Memorandum Department of Planning

RE: Chesterfield Commons, Lot 14 (Schnucks) AAE: Amended Architectural

Planning Commission Staff Report

Project type: Amended Architectural Elevations

Figure 7: Lighting Plan

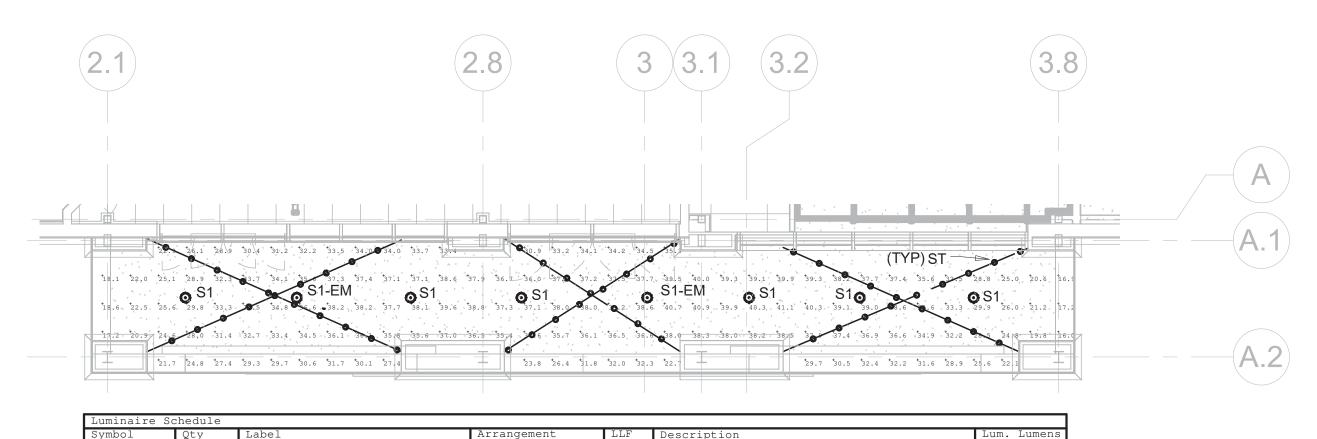
The applicant is proposing festoon lighting under the existing entry canopy. The proposed light is black polymer plastic fixtures with frosted white bulbs of warm white color. The light will remain static. The light fixture is proposed under the canopy but will be visible from outside.
